MFN 06-284

Subject: **Response to NRC Request for Additional Information Letter No. 18
Related to ESBWR Design Certification Application - Containment
Design - RAI Numbers 6.2-11, 6.2-21, 6.2-26 and 6.2-27**

**Response to NRC Request for
Additional Information Letter No. 18
Related to ESBWR Design Certification Application
Containment Design
RAI Numbers 6.2-11, 6.2-21, 6.2-26 and 6.2-27**

Figure 6.2-11.1 Drywell Pressure Responses of 4 LOCA Types

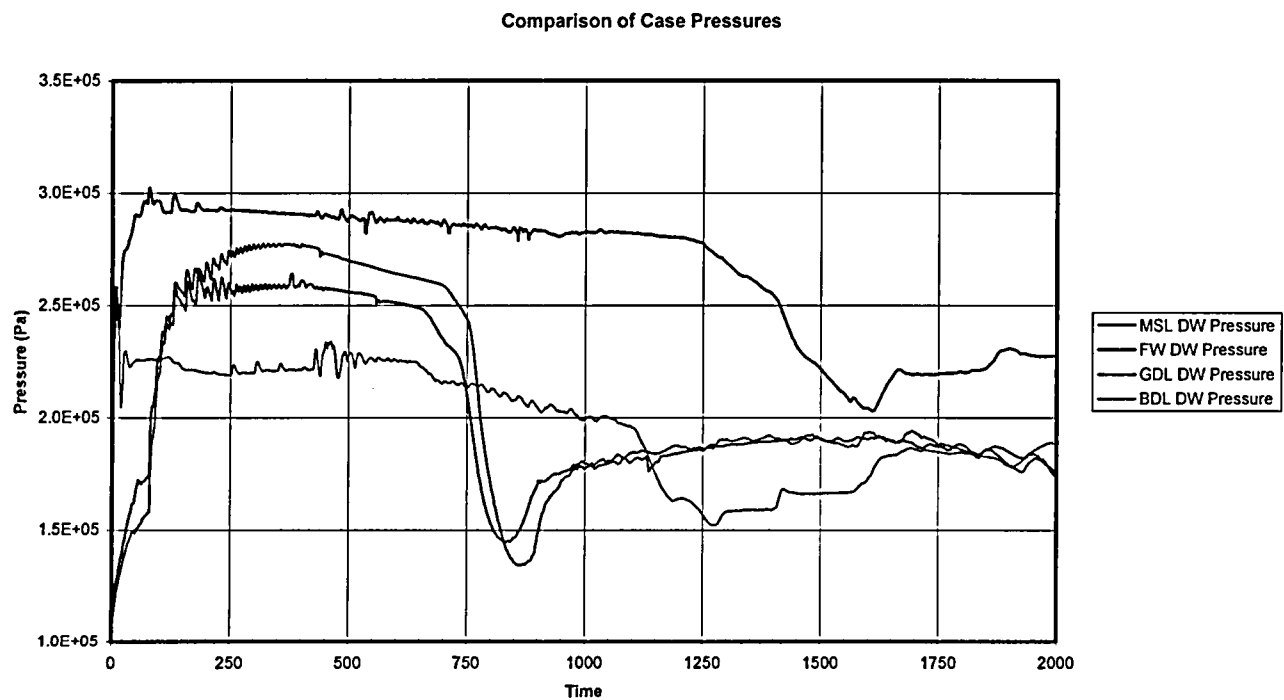
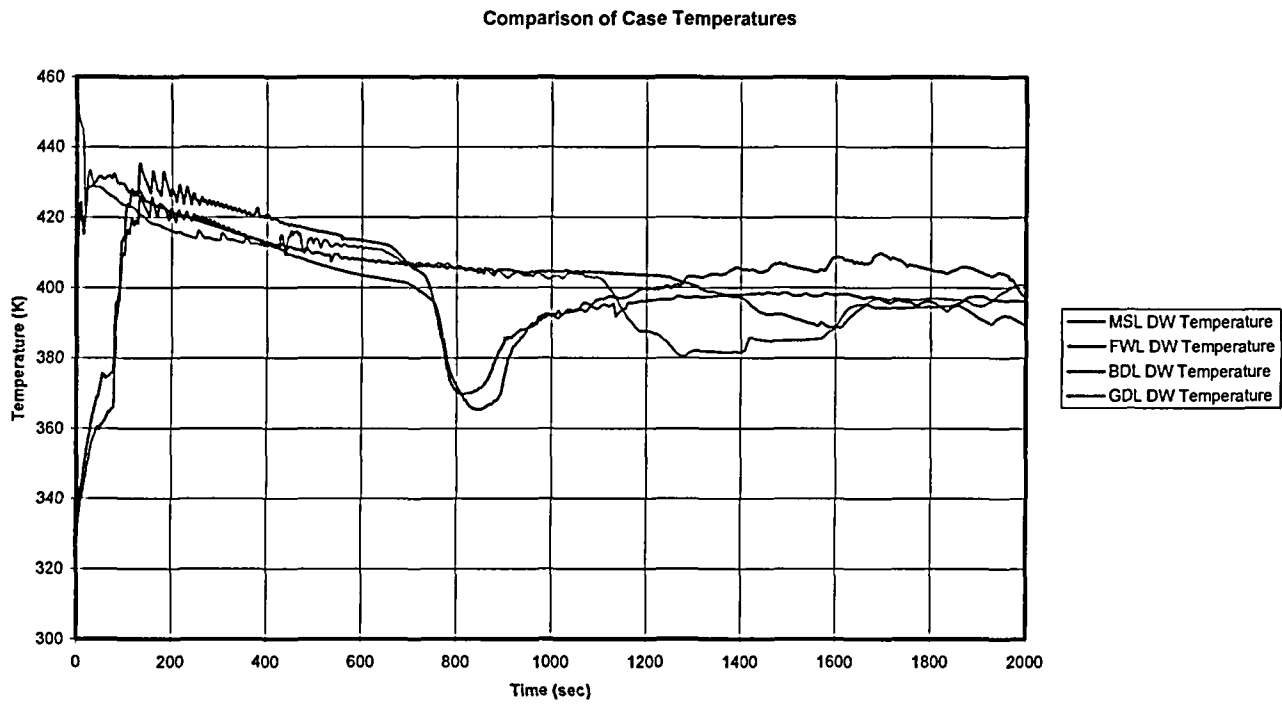
Provide the results of the evaluation(s) and compare to the design value(s). The DCD Section 6.2.1.1.4 indicates that the MSLB will not result in unacceptable results but it does not indicate if other LOCAs were evaluated to conclude this is the limiting case. Provide a discussion on how the limiting cases were identified, for both the drywell and wetwell. Address drywell results and, as appropriate, wetwell results.

Among four design base LOCA break types analyzed for DCD, Feedwater Line (FWL) break results in the highest peak drywell (DW) pressure and Main Steam Line (MSL) break results in the lowest peak DW pressure. The peak pressure of GDCS Injection Line (GDL) or Bottom Drain Line (BDL) break falls between those of FWL and MSL breaks, as shown in Figure 6.2-11.1. DW temperatures are comparable for these 4 types of breaks, except that FWL and MSL cases have higher temperature between 800 and 1100 seconds, as shown in Figure 6.2-11.2. It is therefore adequate to analyze FWL and MSL break scenarios to provide diverse DW environmental conditions which envelope other break locations, for determining the minimum DW pressure and the pressure differential between WW and DW as consequence of inadvertent initiation of drywell spray. The results are tabulated below. An inadvertent drywell spray initiation during a MSLB resulted in a lower DW pressure. An inadvertent drywell spray initiation during a FWLB resulted in a higher WW to DW pressure differentials. The results are all within the design capability. An inadvertent drywell spray initiation during a normal operation was also analyzed and the results were inconsequential.

Results of three analyzed cases are summarized below:

FWL Break	MSL Break	No Break
Drywell Spray Flow Rate (GPM)	2000	1000	2000
Spray initiation Time (sec. after break)	1300	1000	0
Minimum Drywell Pressure (psia)	25.3	17.5	14.9
Maximum Wetwell to Drywell ΔP (psid)	2.88	1.40	0.000028
Design Wetwell to Drywell ΔP (psid)	3.0	3.0	3.0

The second sentence of the last paragraph of DCD Section 6.2.1.1.4 will be revised to read:

“The Feed Water Line (FWL) and Main Steam Line (MSL) break scenarios provide diverse Drywell environmental conditions which envelope the other break locations. The results of the FWL and MSL break analyses show that the containment does not reach a negative pressure relative to the reactor building, and the maximum Wetwell-Drywell differential pressures are within the design capability.”
